**RIVERDALE CITY PLANNING COMMISSION AGENDA
CIVIC CENTER - 4600 S. WEBER RIVER DR.
TUESDAY – MAY 24, 2016**

1. Consideration of Infill Lot Development/Preliminary Residential Subdivision Approval for A K Walker Subdivision, 850 West 4375 South, Riverdale

2. Consideration of Infill Lot Development/Residential Small Subdivision Approval for Hill Family Subdivision, 300 West Highland Drive, Riverdale

Infill Lot Development/Preliminary Residential Subdivision Plan Review – A K Walker Subdivision Approximately 850 West 4375 South

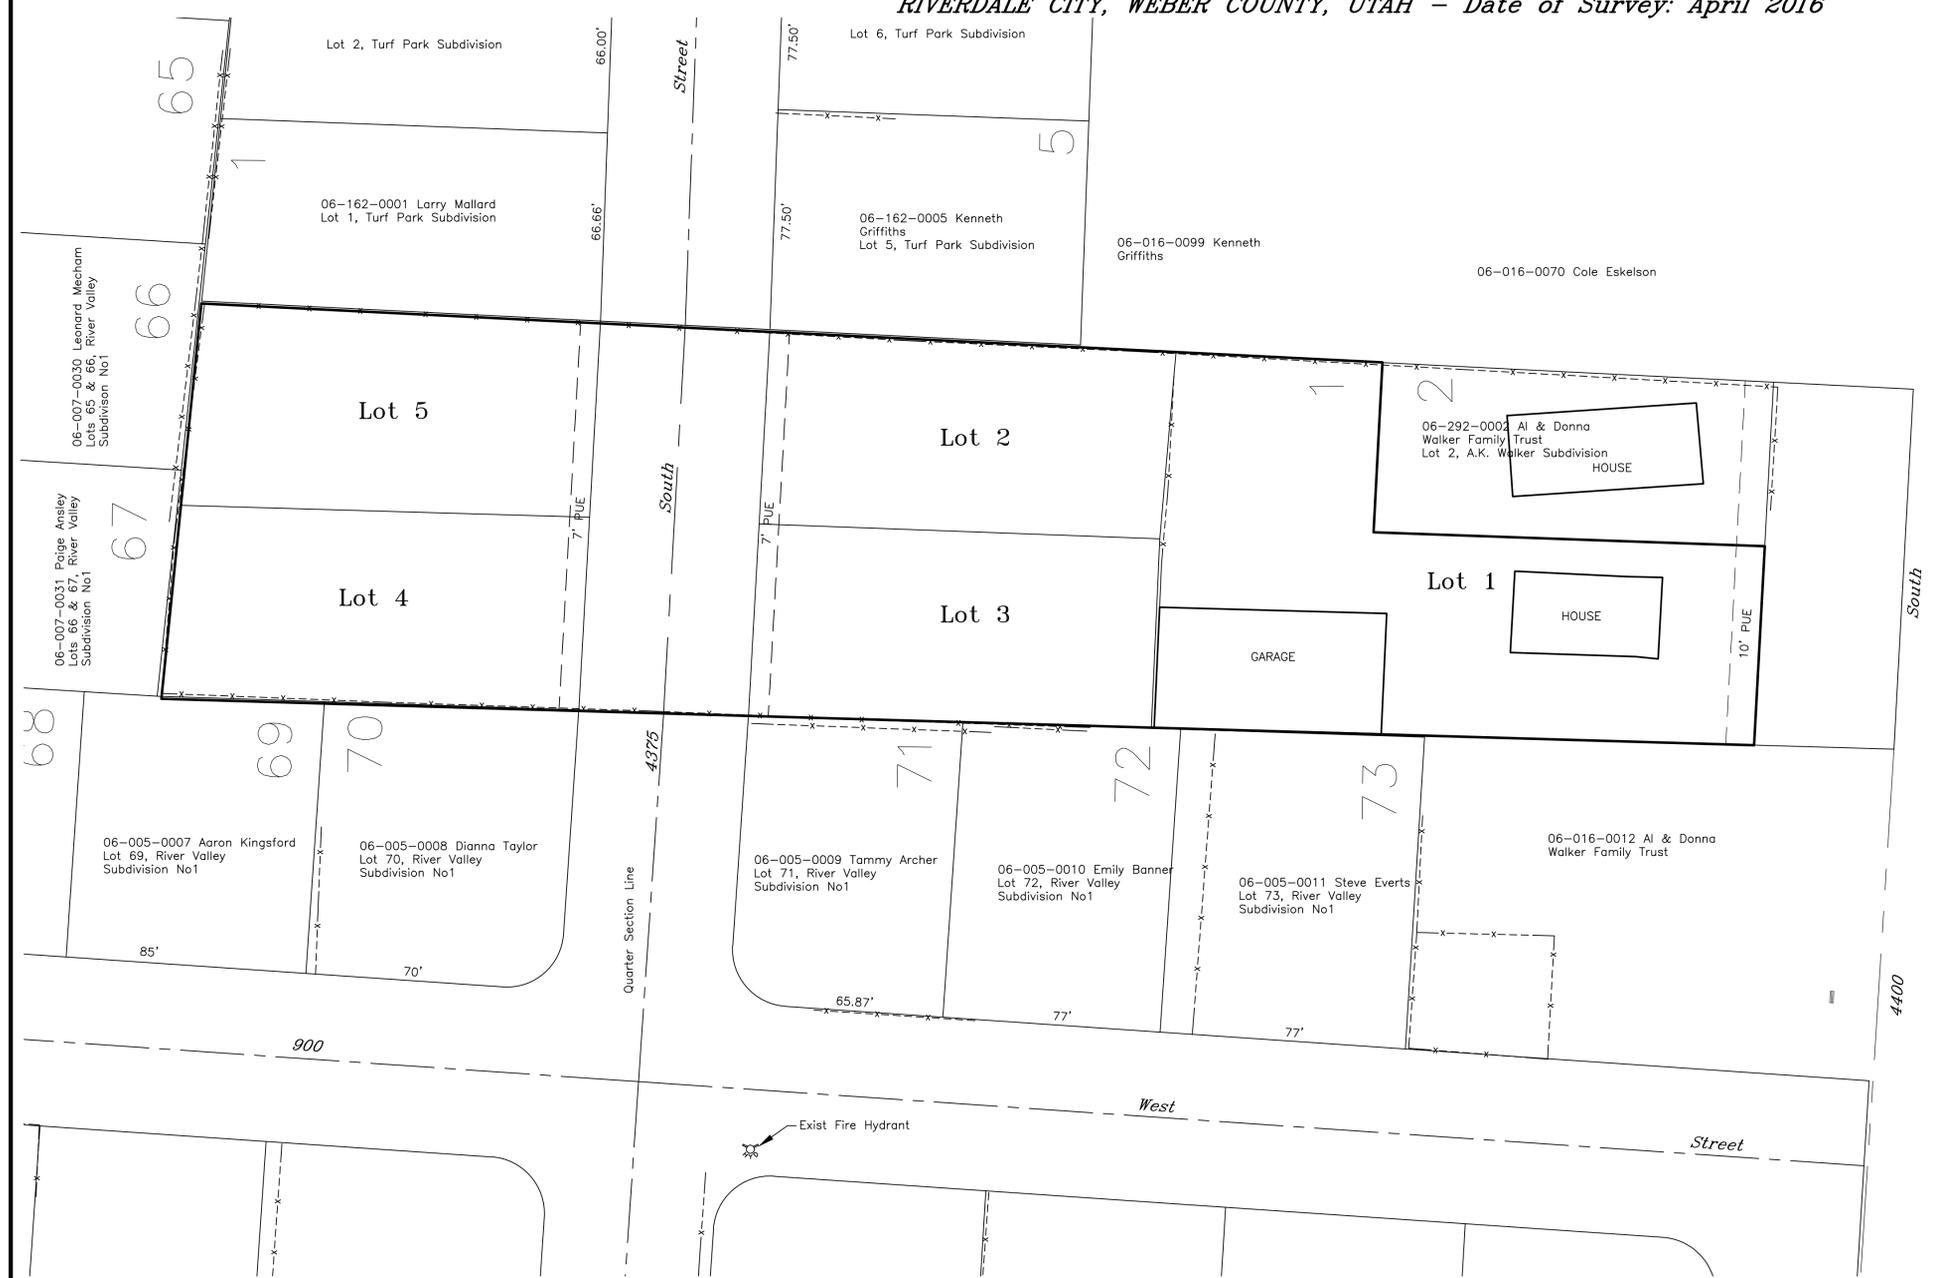
1. The Plat “Boundary” fails to close by approximately 0.52’.
2. The lot addresses are needed for all five (5) subdivision lots. The addresses can be placed on the individual lots or in a table on the Plat.
3. The “North Arrow” is facing the wrong direction and should be rotated.
4. The survey “Basis of Bearing” is needed to be placed on the Plat drawing.
5. A 10’ wide public utility easement is needed along the frontage of lots # 2 through Lot #5.

Typical Section - 30" Curb & Gutter
Not to Scale

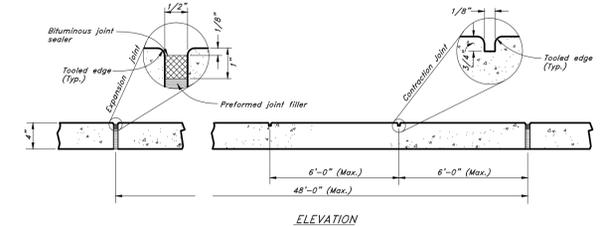
3. The City standard minimum curb & gutter slope is 0.5%. It appears the new South - curb & gutter slope for the new subdivision area will be very close to this minimum. The new North - curb & gutter slope appears to be okay. This will be further reviewed with the completion of the Plan & Profile drawing.

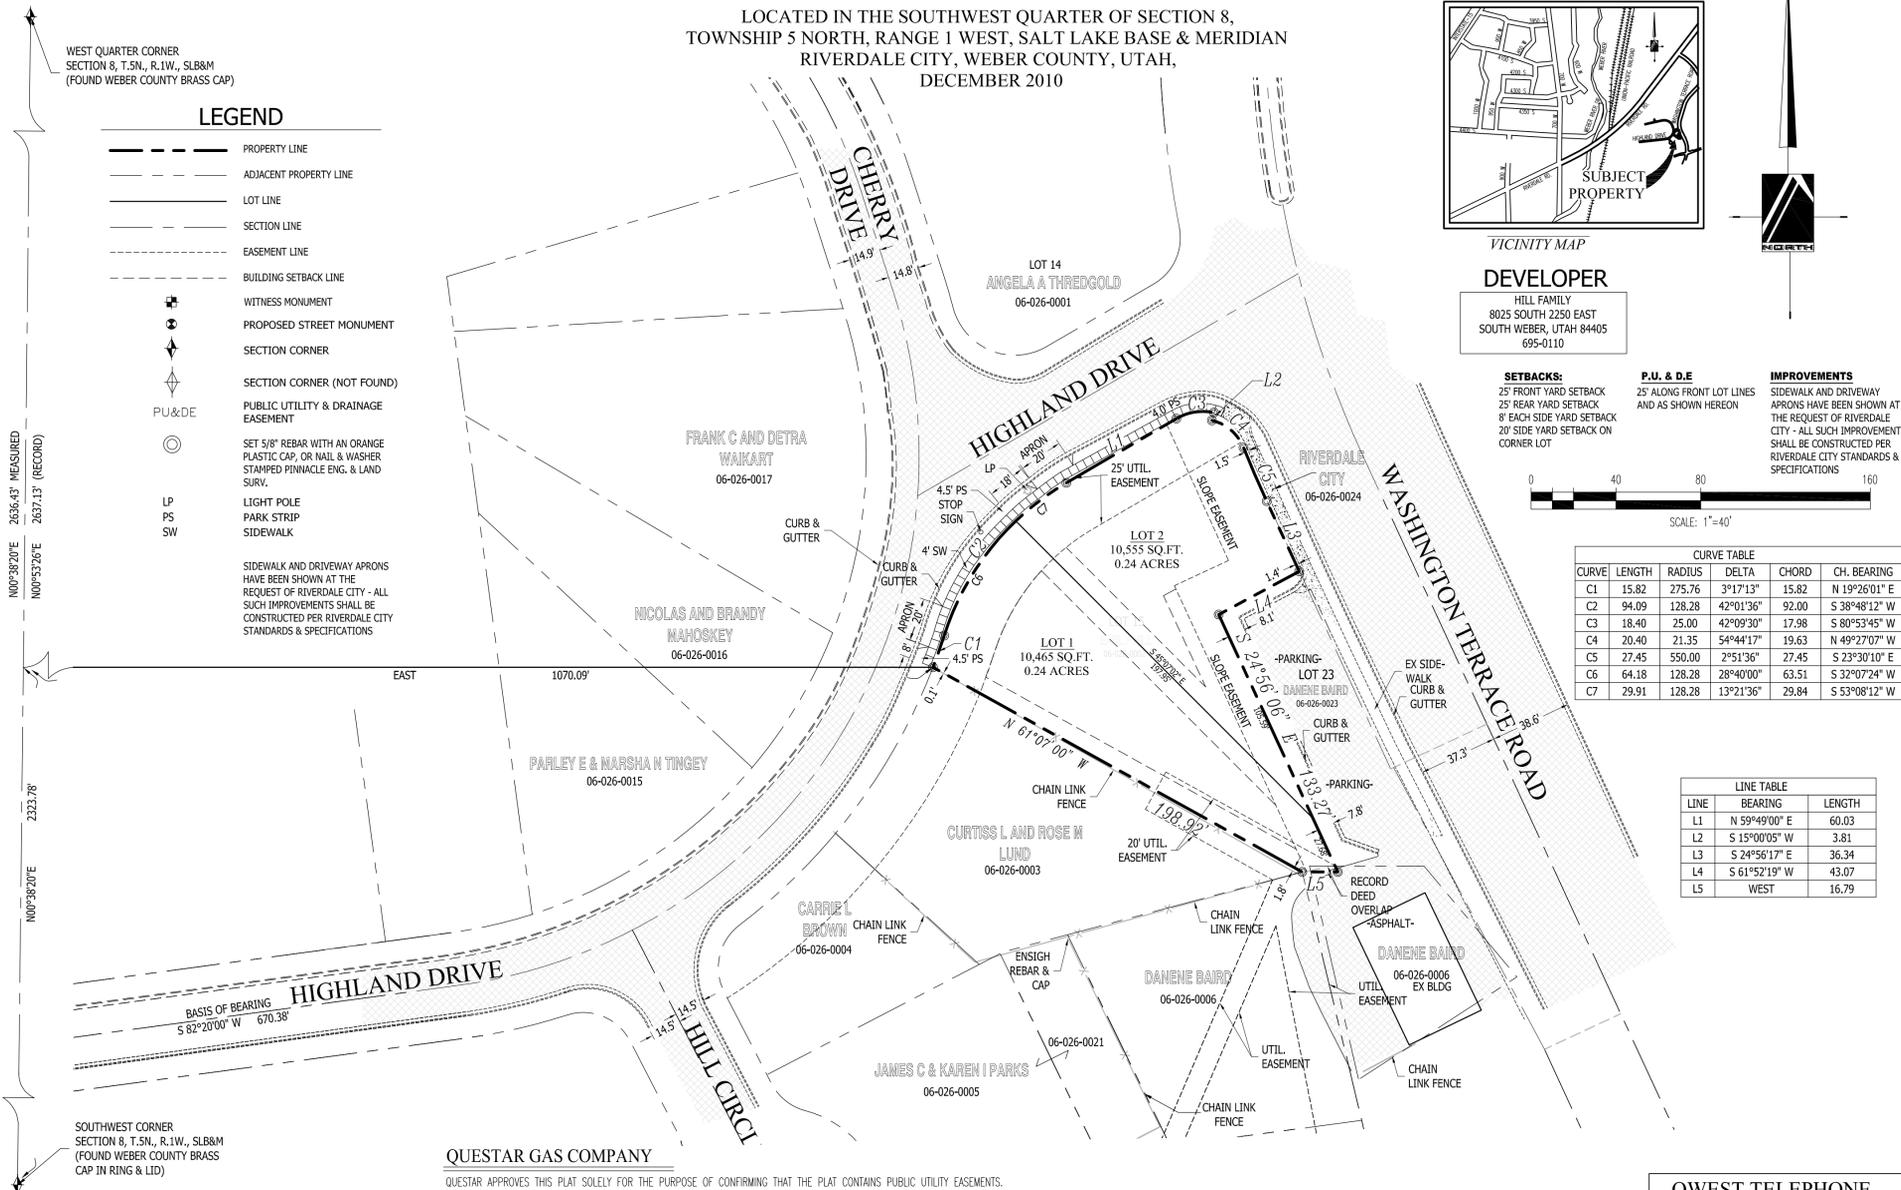
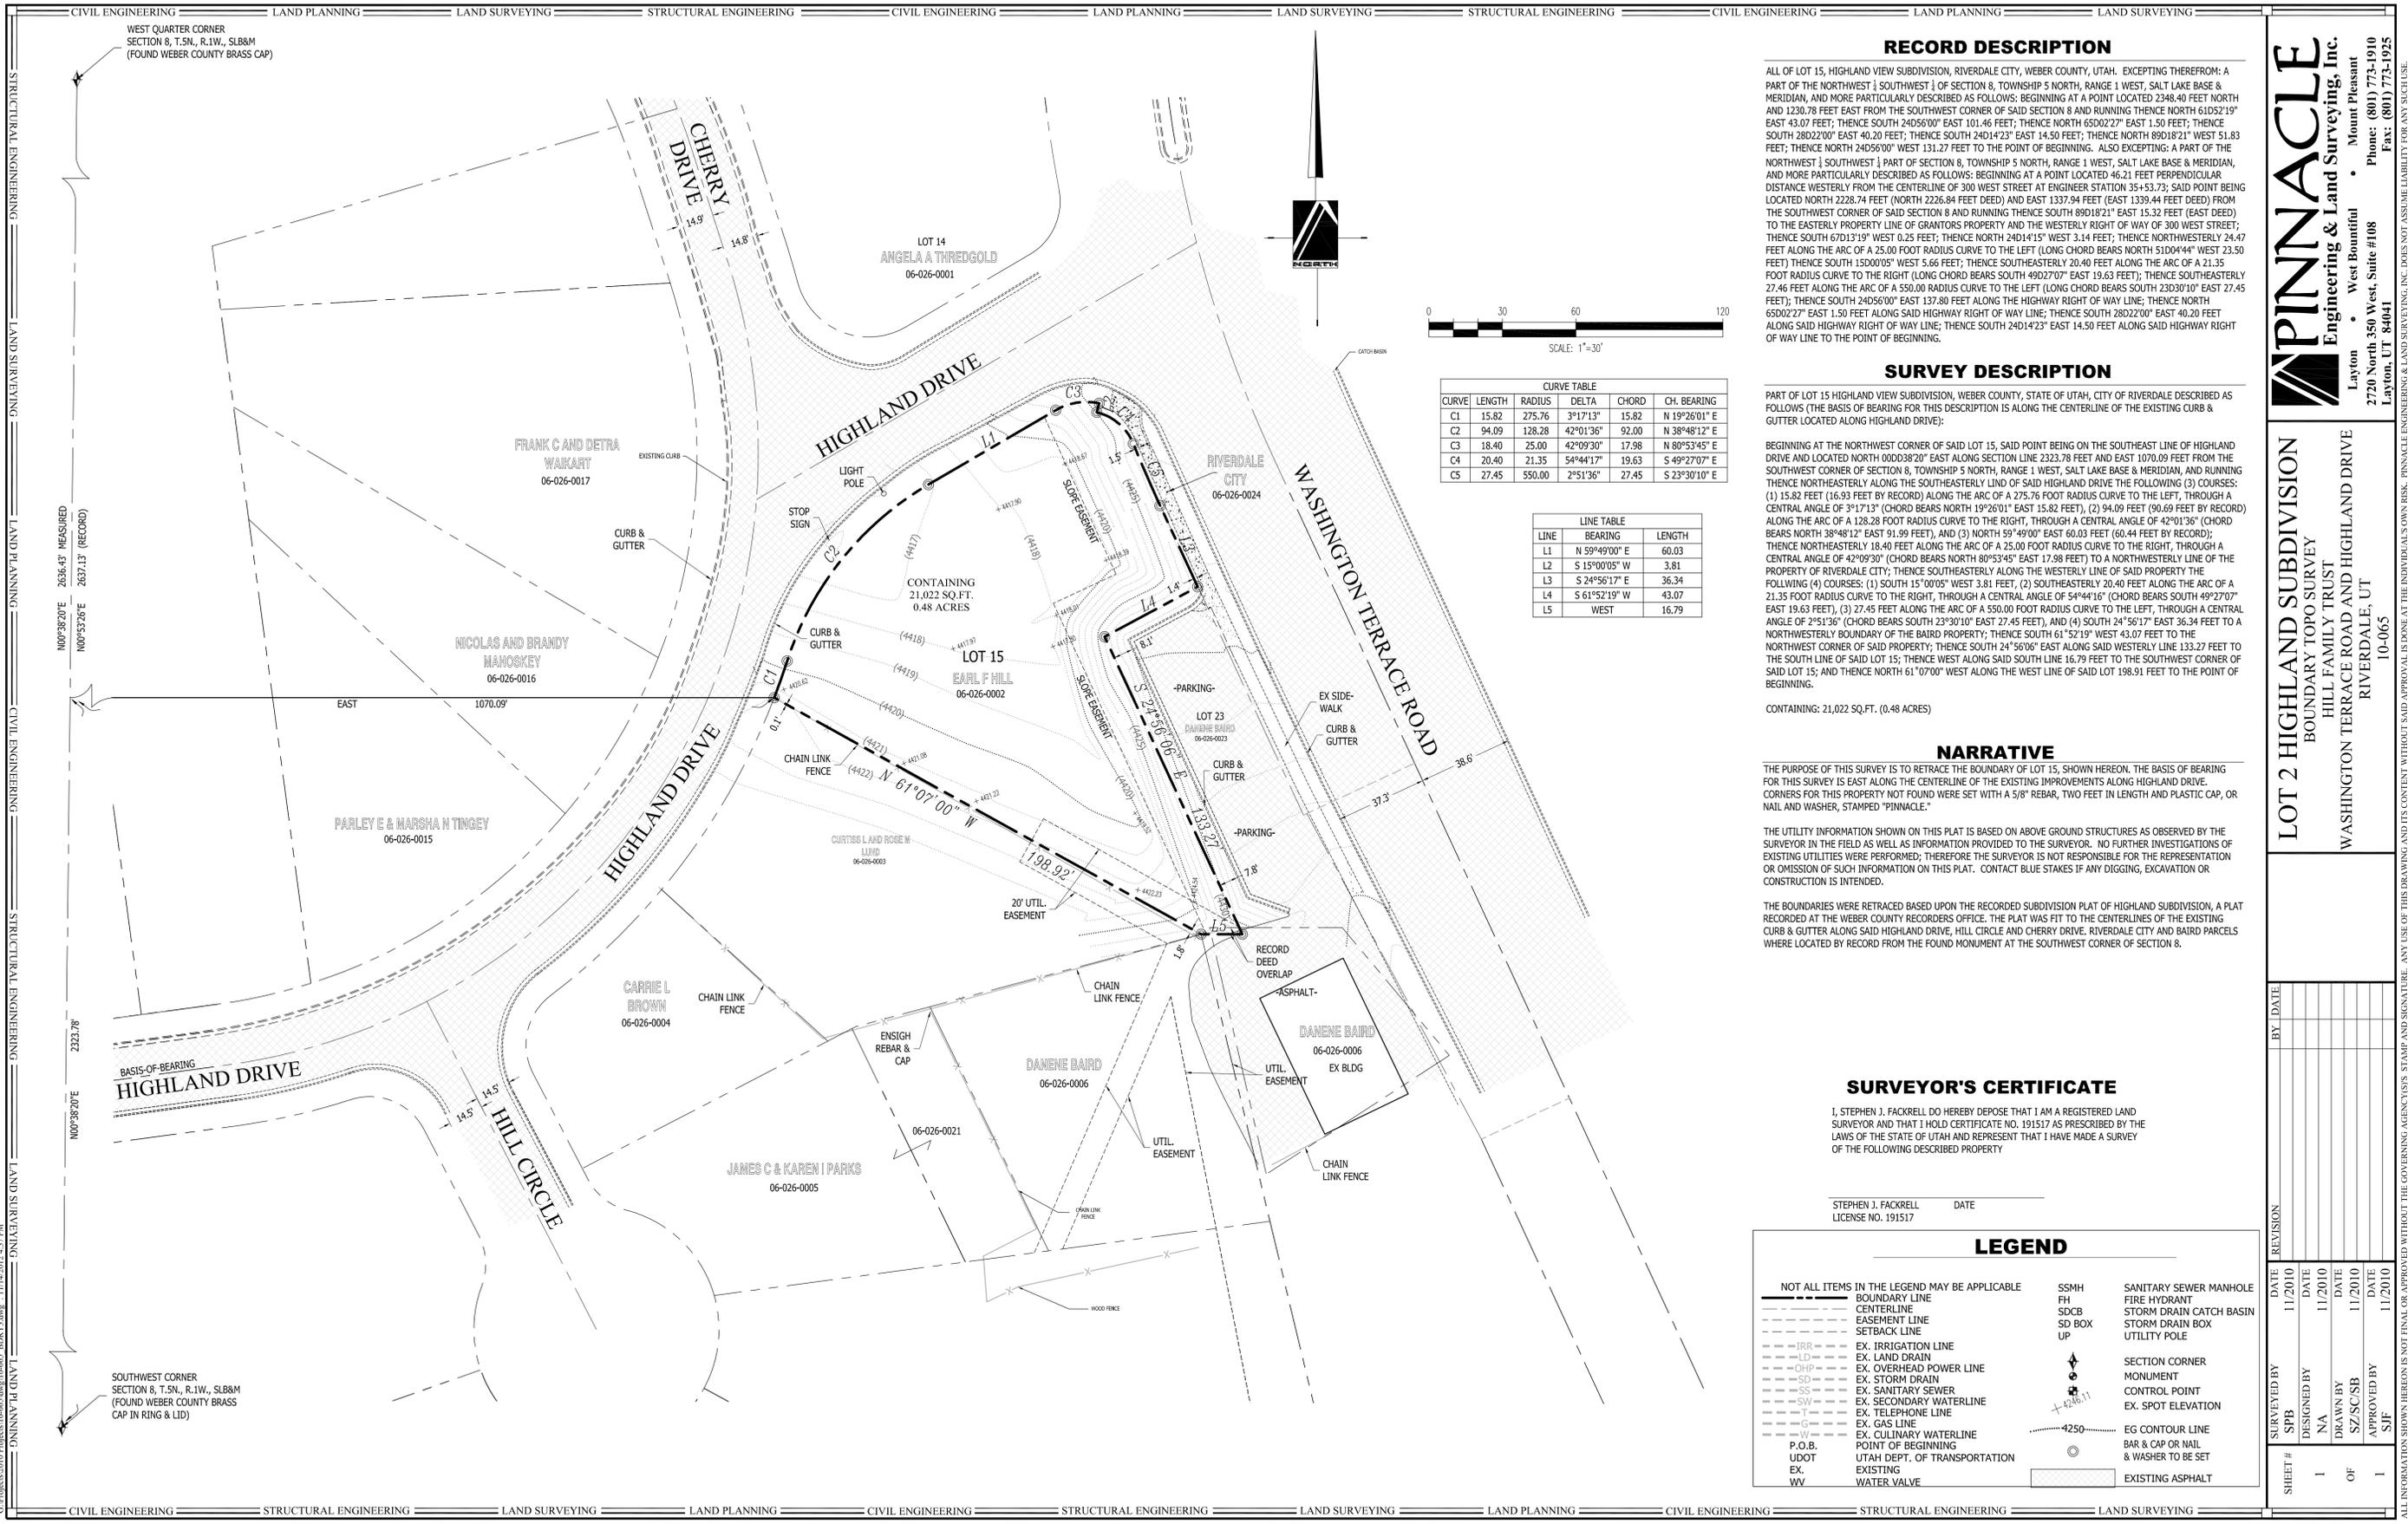
1. The Plat "Boundary Description" and "Plat Drawing" have several errors which need to be corrected. I have included a scan drawing of my review of the description and drawing and the mathematical errors are noted on the scanned drawing.
